PRE-APPLICATION CONFERENCE
Vineyard Vista Subdivision (2022-039-PAC.)
 Meeting conducted on December 7, 2022 at 1:30 p.m.

Site Address	2025 & 2103 Northeast North Fork Avenue, La Center, WA 98629 (Parcel no. 258898000 & 258903000)
Legal Description	#19 and #36 Section 34, Township 5N, Range 1E, WM
Applicant	Lincoln Wolverton Chinookan, LLC 360.606.8986 lincolnwolverton@hotmail.com P.O. Box 886, La Center, WA 98629
Applicant's Representative	Mason Wolfe Wolfe Project Management, LLC 360.907.9588 mason@wolfepm.com 2401 West Main Street, Suite 210, Battle Ground, WA 98604
Property Owner	Same as applicant
Proposal	Subdivide 28.75 acres into 99 single-family residential lots in the LDR-7.5 zone with urban holding overlay (UH-10). Includes at minimum: mass grading, public street improvements, public utility improvements, and critical areas permits.
Date of Issue	December 15, 2022

Figure 1: Type I CARAs (area in red)

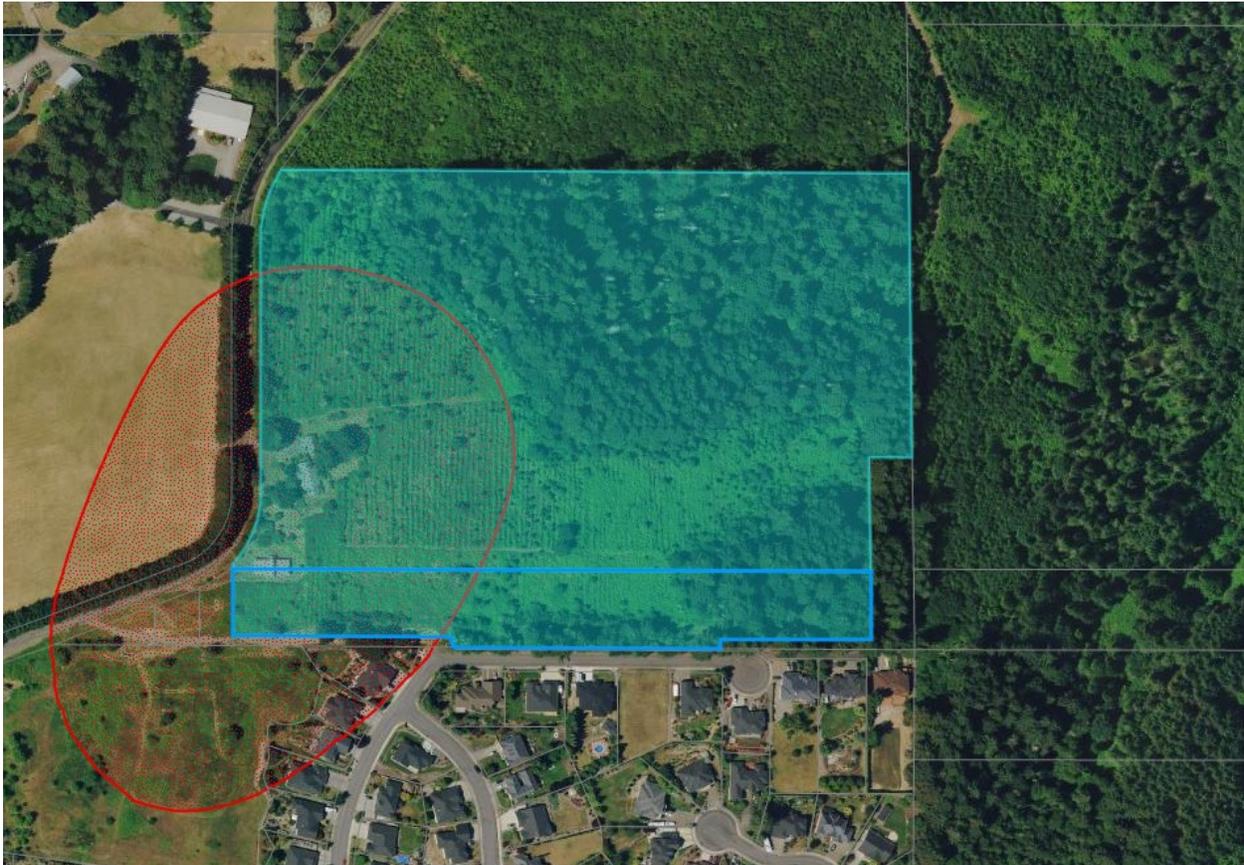
The City of La Center and Clark County MapsOnline identifies Type I and Type II CARAs on the site. Type I CARAs are mapped on the western and southwestern portion of the site (see Figure 1), while the remaining portion of the site is mapped as Type II CARAs. Type I CARAs require a critical areas permit and a Level 1 Hydrogeological Report in accordance with LCMC 18.300.090)(1)(d). The report shall be prepared, signed, and dated by a professional who is licensed in the state of Washington in

hydrogeology or geology and provided with the application. Please see prior note about the three lots to the southwest of the site where former wells were decommissioned and reports in Attachment B. If the applicant can verify that no other wells exist in the vicinity, a hydrogeological assessment and critical areas permit is not required.

Figure 4: Severe Erosion Hazard Areas (in brown)

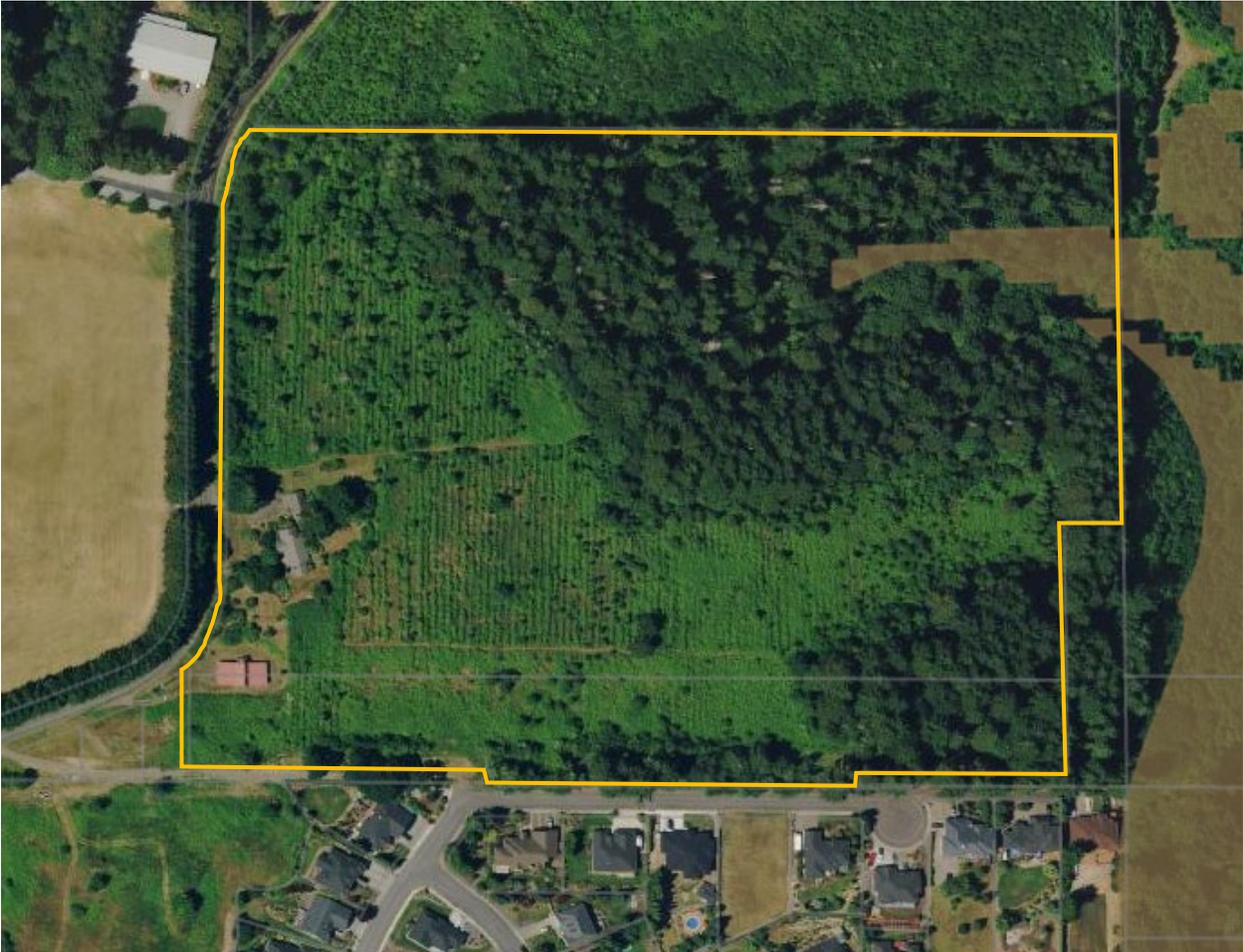
Clark County maps an area on the northeast side of the site as a severe erosion hazard area (Figure 4), which is a regulated geologically hazardous critical area. Development on lands classified as an erosion hazard areas are prohibited unless the applicant meets the requirements of LCMC 18.300.090(4)(b)(i) and LCMC 18.300.090(4)(c & e). This includes erosion hazard area buffers as recommended in an approved geotechnical report. The applicant must provide an erosion control plan that meets the requirements of LCMC 18.300.090(4)(e)(ii).

ST-29

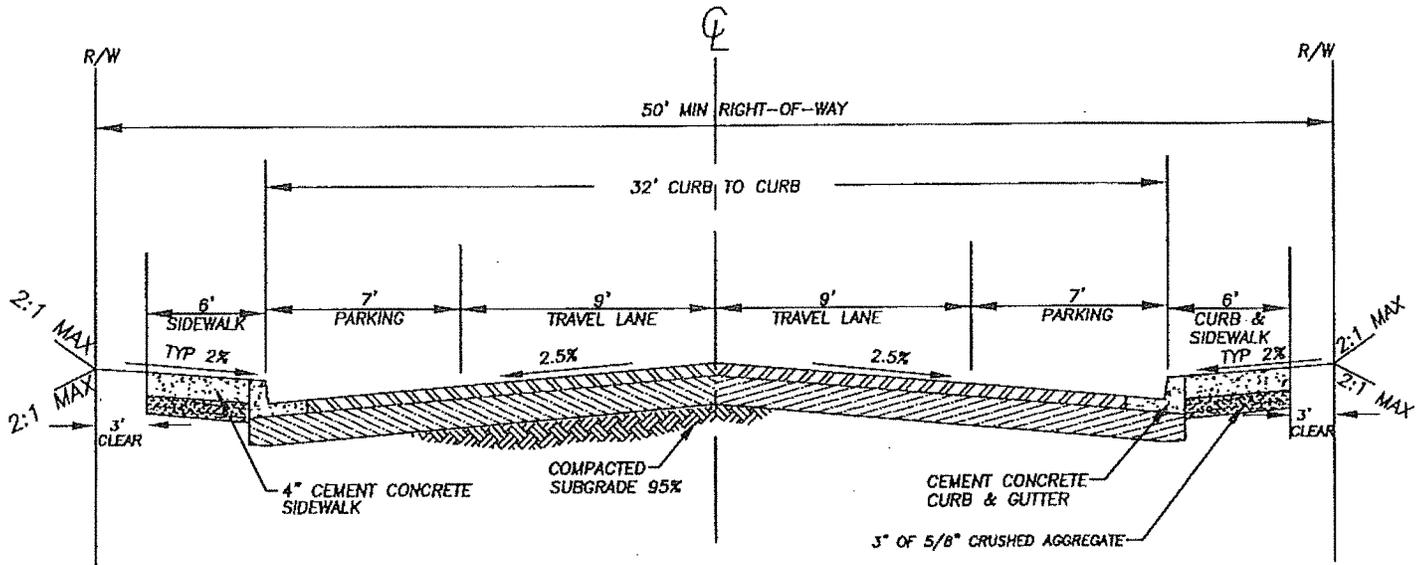
Response: The minimum radius is 45-foot curb-to-curb for a cul-de-sac. See Detail ST-29 in Attachment C.
